Appendices to the ROD

FINAL EIS, ERRATA SHEET, AND APPENDICES

ERRATA SHEET

This errata sheet documents minor changes, additions, or deletions to the Final Environmental Impact Statement (FEIS) for the Baltimore Vegetation Management Project (VMP). Changes, additions, or deletions are denoted in *italics*.

Updated Figure 3.7.1. Main Known Area of Glossy Buckthorn Infestation.

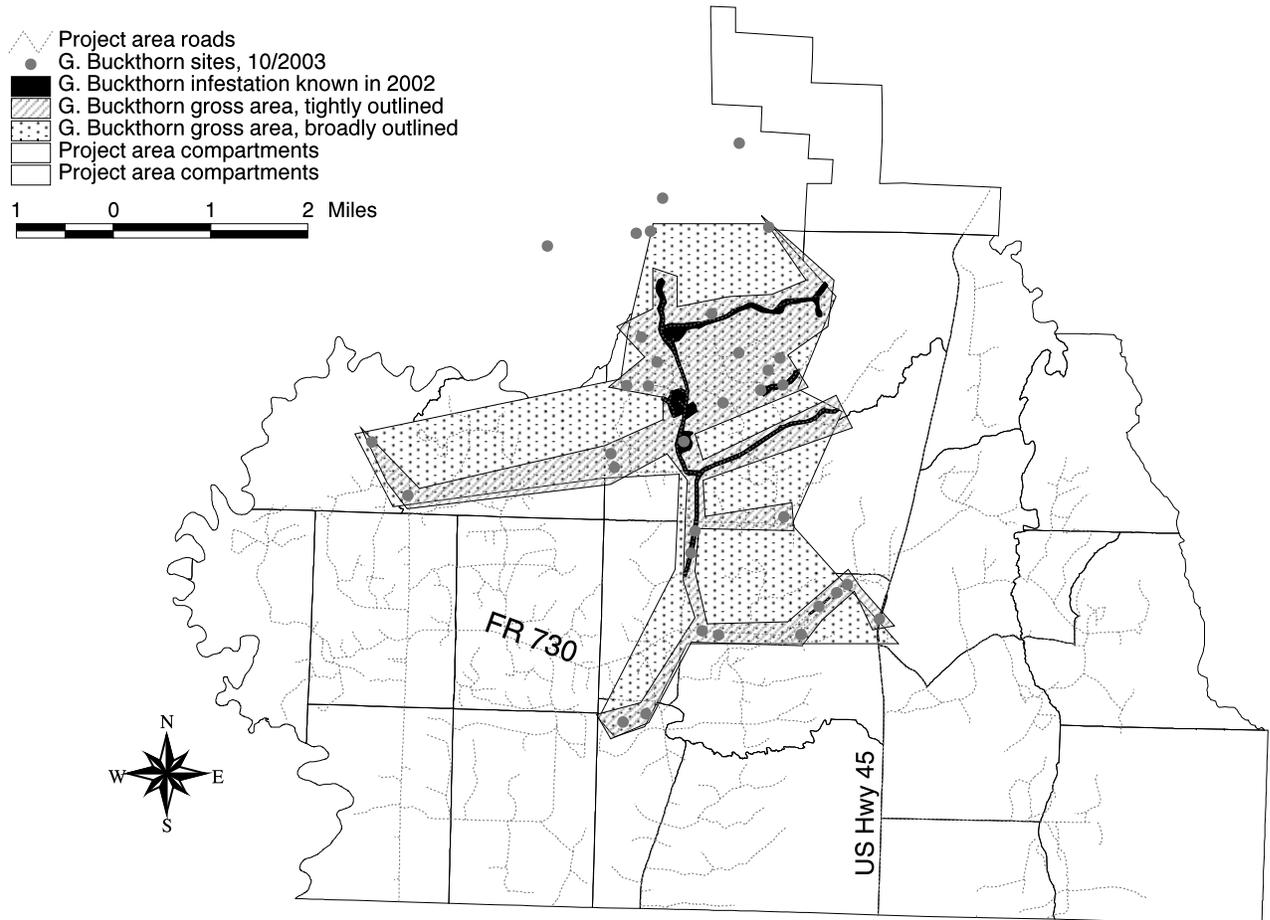
Page 3-78, DEIS – Figure 3.7.1, *delete* and replace with the following updated figure:

Page 3-78, DEIS – first paragraph in right column, *delete* and replace with the following two paragraphs:

“The glossy buckthorn infestation, which is of highest concern, was first observed during field surveys for rare plants in late 2002. The full extent of the infestation has not yet been determined, but additional mapping in 2003 shows that the infestation is much larger than noted in 2002. Within the project area, it appears to be centered on, or at least very dense within, two shrub thicket wetlands, and to extend from there into moist woods. The infestation also occurs outside the project area, and the overall infestation center may be off the Forest, in the Victoria area.”

Figure 3.7.1 shows the known infestation area as of October 2003. Additional sites found in 2003 are shown as gray dots. The gross area of infestation can be mapped by using these dots as the perimeter. Depending on how inclusively the lines are drawn, the gross infestation area appears to range from 3200 to 6800-some acres. There are certainly more sites within the gross area that have not yet been recorded. The main area mapped in 2002 lies primarily along roads. This is partially due to our mapping because we had mostly checked for the shrub from the roads and had not canvassed the adjacent woods. However, the roads can also be corridors for spread of this plant.”
